EAST CENTRAL RAILWAY

Sub:- Inter Railway Audit of EMU, MEMU crashed.

Sub:- Action taken against RDSO observations during safety Audit of EMU/MEMU.

SAFETY AUDIT REPORT OF EAST CENTRAL RAILWAY

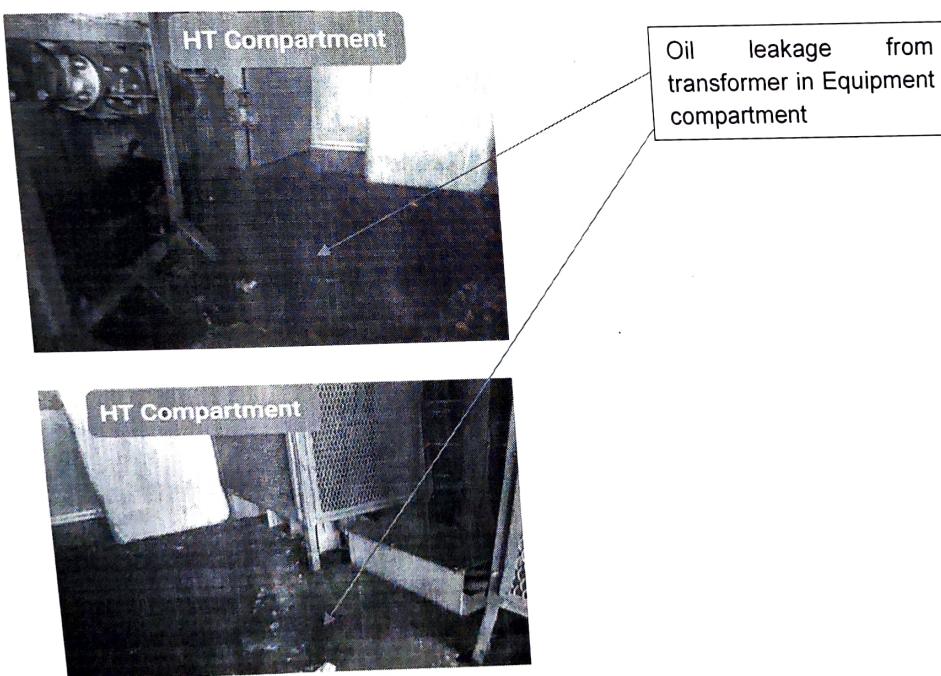
- (i) Oil leakage from transformer was observed in Equipment compartment of the motor coach.

Railway	Name of Car shed	RDSO Observations	Remarks	Action taken
ECR	MEMU Car shed . Jhajha	Oil leakage from Transformer in equipment compartment	There was no Transformer oil leakage in equipment (HT) compartment. The Transformer oil noticed was accumulated in tray fitted under conservator tank. Whenever BIR occurs during run on line, working motorman/staff operate the knob fitted with BUD to discharge the gas to reset BIR. During resetting of BIR, some quantity of Transformer oil also comes out and get accumulated in tray.	The accumulated oil is cleaned during maintenance. This is normal practice
		Fire extinguisher is not available in equipment compartment (HT).	During maintenance it was taken out for replacement of discharge pipe.	After replacement of discharge pipe fire extinguisher has been provided
		Danger & X(cross) was indicated improper	-----	It has been made proper
		In LT panel, 125 A fuse was provided instead of 160 A for main compressor	It was observed that due to fitment of 160 A fuse, main compressor motors were getting burnt accordingly local modification for fitment of 125 A fuse instead of 160A with detailed reason has been done by SDAH division of ER and such practice being followed by all MEMU car shed of ER since 1998 January. Same practice is also being followed by MEMU shed Jhajha. No case of main compressor motor burning is observed with such practice (Copy of modification sheet of SDAH division ER is attached)	Hence 125 A fuse instead of 160 is provided

Danger & X (cross)
was indicated
improper

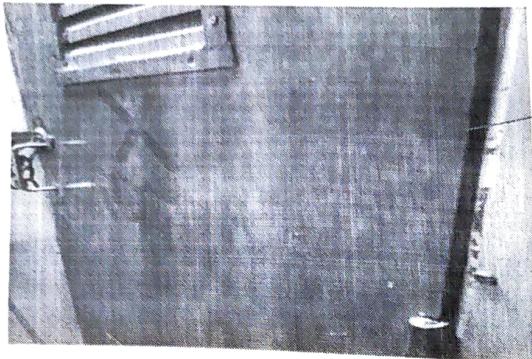
- (ii) fire extinguisher is not available in the Equipment compartment.
- (iii) Danger & X (cross) was painted, which is not proper. However, danger plate as per IS: 2551 (latest version) with 1 mm thick anodized aluminum sheet, to be riveted on outer side of the coach with letter etched and painted in white colour with red background.

125A fuse was
provided instead of
160 A fuse

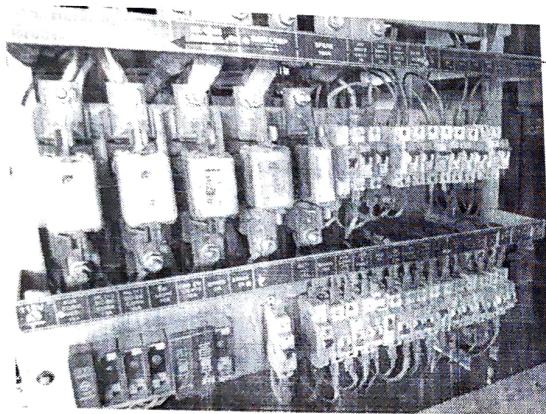
- (i) In LT panel, 125A fuse was provided instead of 160 A for main compressor

63A fuse was
provided instead of
120 A fuse

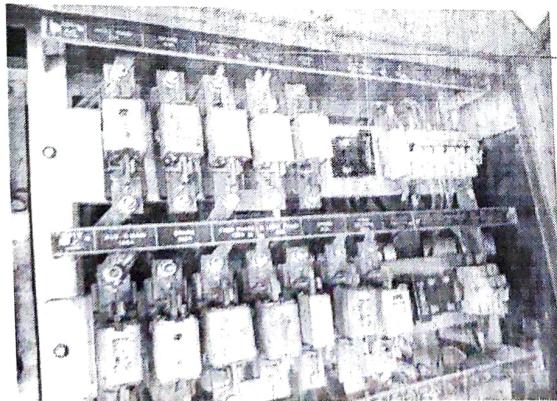
- (ii) 63A fuse is provided instead of 120 A for fans phase.

63 A fuse is provided instead of 120 A for fan phase	Camtech vide CAMTECH/2009/E/TSD/AC EMU/1.1 December 2009 has circulated trouble shooting directory for MEMU with 63 A fuse for fan phase.	Hence 63 A fuse is being provided for fan phase instead of 120A
		No any instruction for operation of fire extinguishers was pasted.	All new fire extinguishers (FE) were provided with operating instruction and some of old FE these instructions were defaced.	Fire extinguisher operating instruction is being ensured on all fire extinguishers
		Only one fire extinguisher was available.	Other was taken out for replacement during maintenance of MEMU rake.	Two nos is being provided

No any instruction for operation of fire extinguishers was pasted

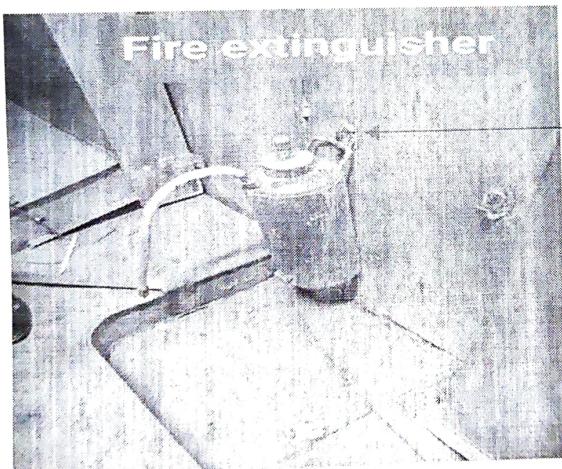
iii)- Fire extinguishers were placed in driving cabs. No any instruction for operation of fire extinguishers was pasted near fire extinguishers. However, as per para 8.4.3 of Code of practice for prevention of fires on EMUs & MEMUs no. RDSO/PE/CP/EMU/0001-2003(Rev. 0) with Amendment no. 1, all the fire extinguishers shall carry an instruction plate wherein the clear instruction for operation shall be written in English & hindi and any other regional language. Checking and refilling date also not clearly mentioned on the fire extinguishers. Fire extinguishers were not properly clamped and was found in dirty condition. In one of the cab only one fire extinguisher was provided.

only one fire was available

Simplified battery chargers was found very dusty.

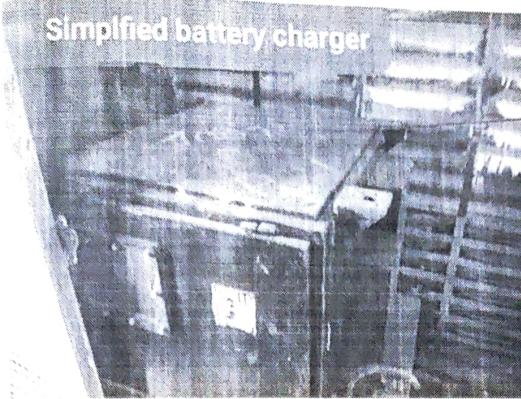
iv)-Simplified battery chargers in maximum coaches were also found in dusty condition.

Simplified battery charger was found very dusty.	As the MEMU rake was under maintenance and sweeping/cleaning of coaches, equipment along with maintenance work was going on. Hence it was observed dusty during safety audit.	Cleaning being ensured during maintenance
		Constant voltage transformer was found very dusty.	Do	Do
		Light fittings & fans in coaches were found very dusty.	Do	Do

Constant voltage transformer was found very dusty

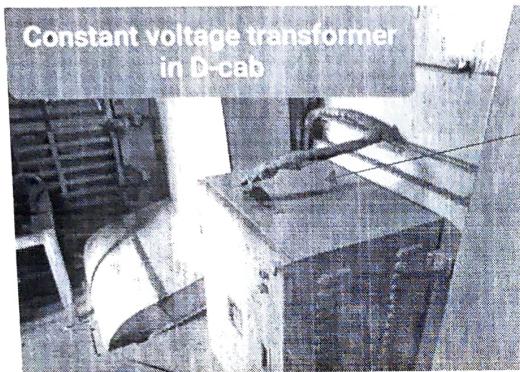
v)-Constant voltage transformer was found very dusty
